INDIAN RUN DAM

PHASE I INSPECTION REPORT NATIONAL DAM INSPECTION PROGRAM

INDIAN RUN DAM
SCHUYLKILL COUNTY, PENNSYLVANIA
NATIONAL I.D. NO. PA 00696

Name of Dam: Indian Run Dam
County Located: Schuylkill County
State Located: Pennsylvania
Stream: Indian Run Creek
Coordinates: Latitude 40° 39.3' Longitude 76° 14.1'
Date of Inspection: 3 July 1978

SEEPAGE LOCATION PLAN
INDIAN RUN DAM
SHEET 5a OF 11

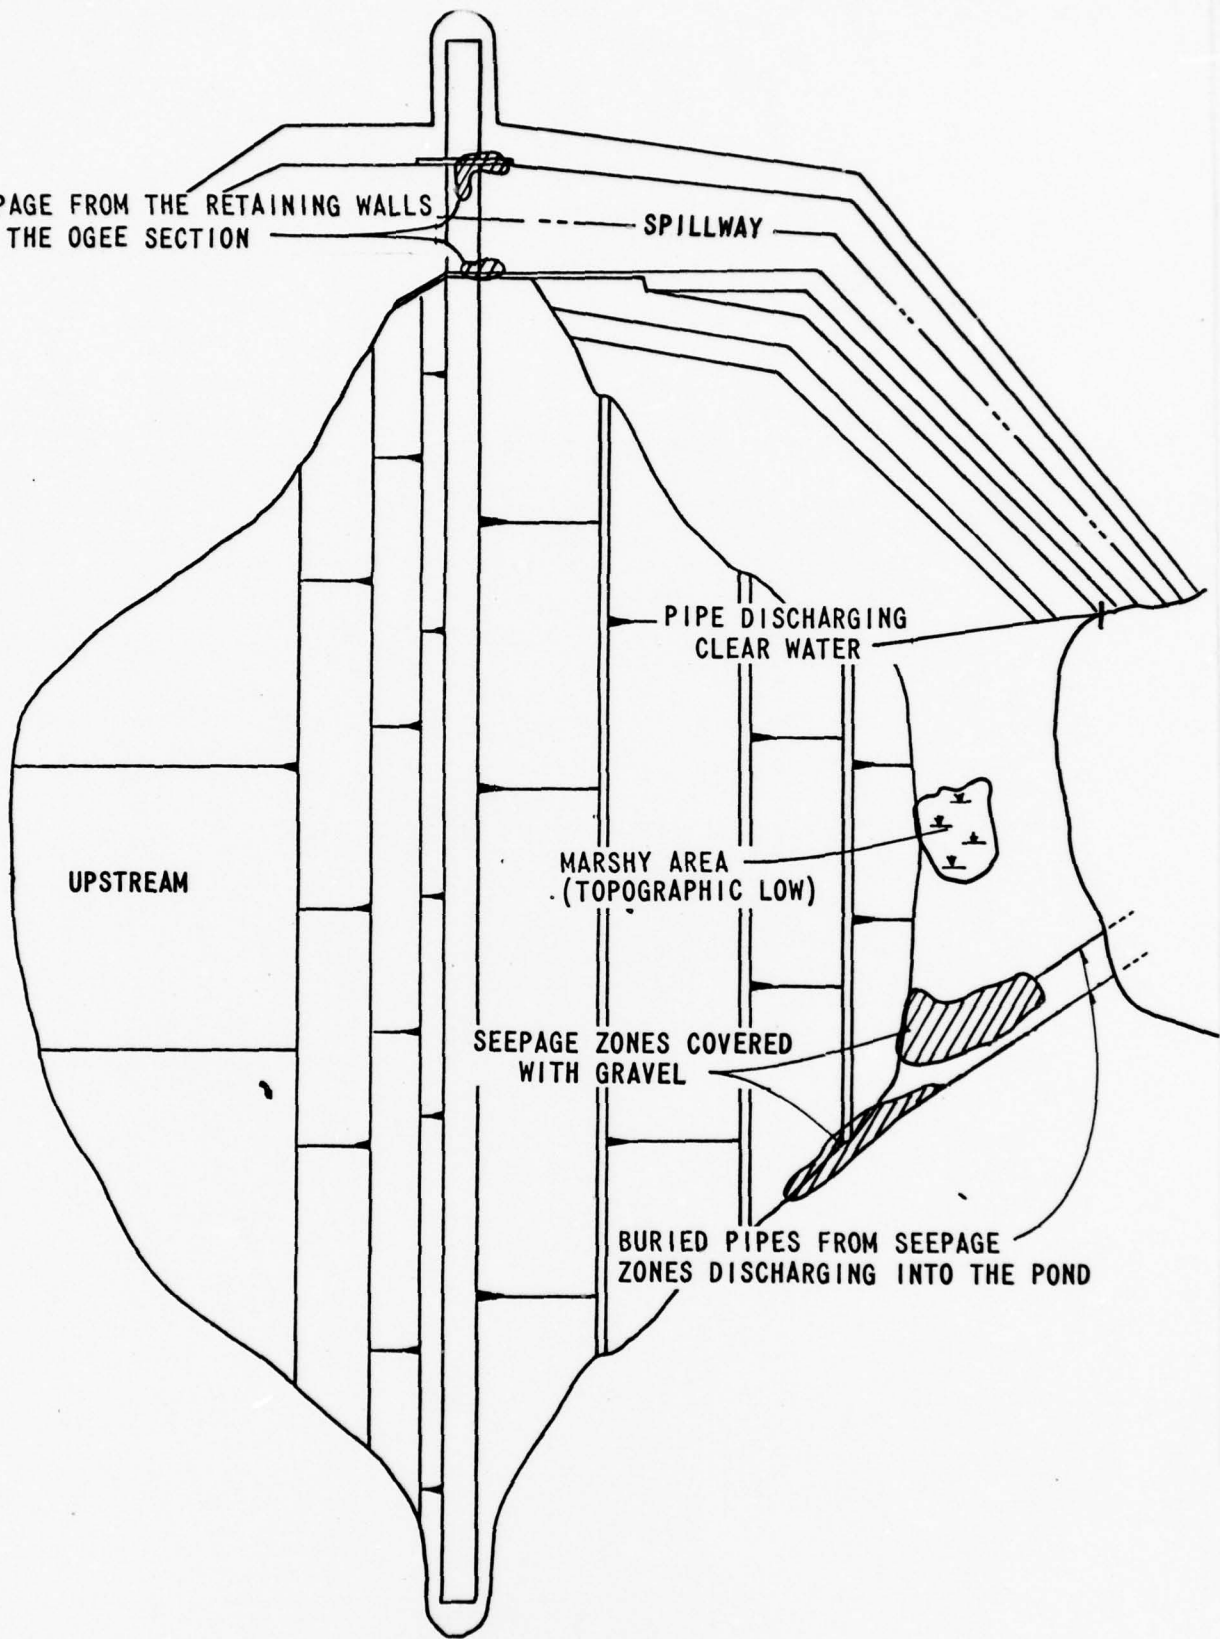
Some seepage was observed along the right abutment of the dam approximately two thirds of the way down the slope. Seepage zones noted in the DER files were found, and observed. They have been excavated; filled with gravel, and drainage pipes now lead to the lower pond. See sheet 5a.

Three drain pipes were noted as shown on sheet 5a.

PHOTOGRAPH NO. 6

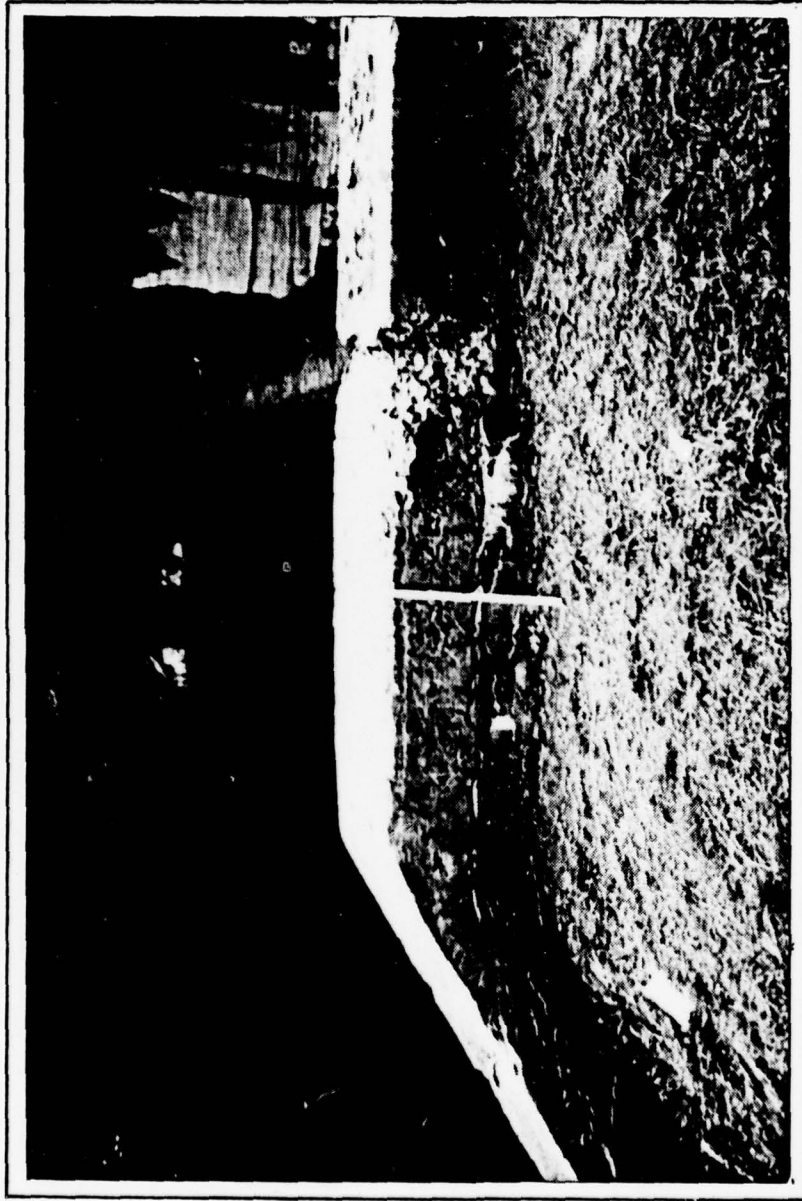
SPALLED CONCRETE OF SPILLWAY WALLS.
NOTE SETTLEMENT OF EMBANKMENT ADJACENT
TO WING WALLS.

PHOTOGRAPH NO. 7

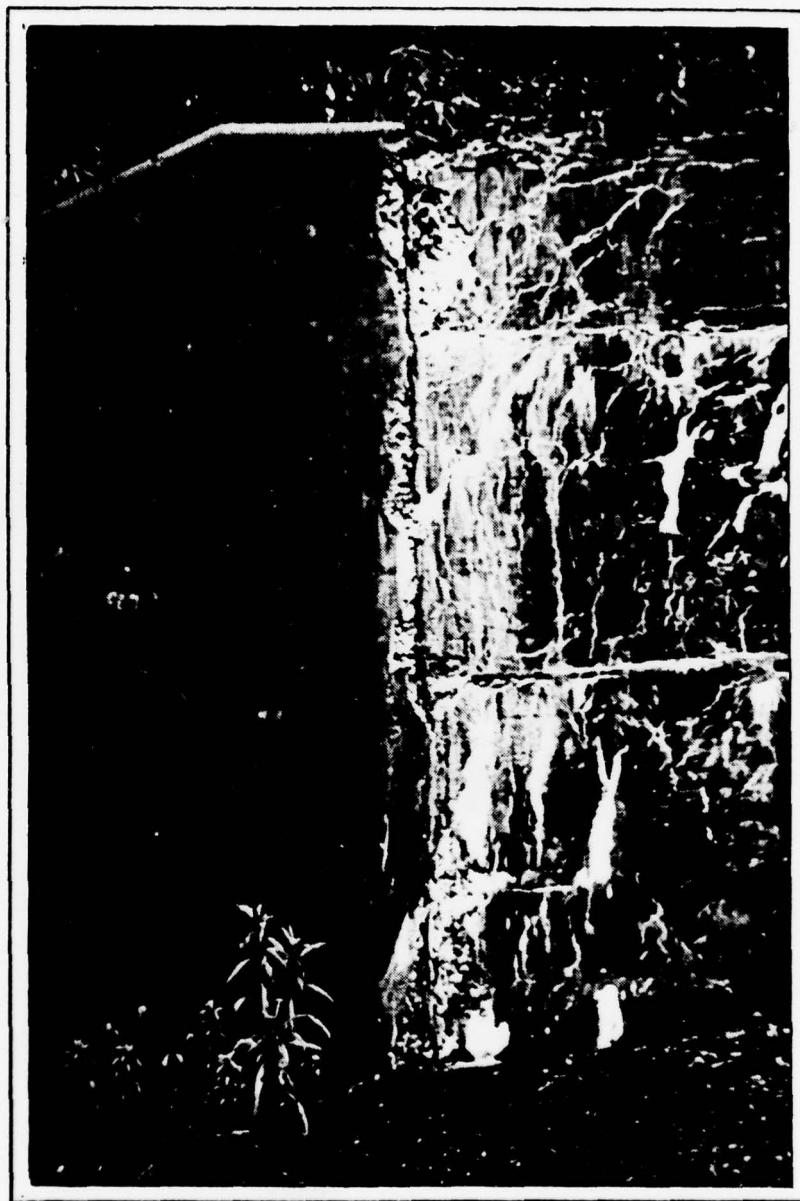
PRINCIPAL SPILLWAY. NOTE CONCRETE
DETERIORATION AND EROSION ADJACENT
TO WING WALLS. DESIGN CALLED FOR
FILL TO TOP OF WALLS.
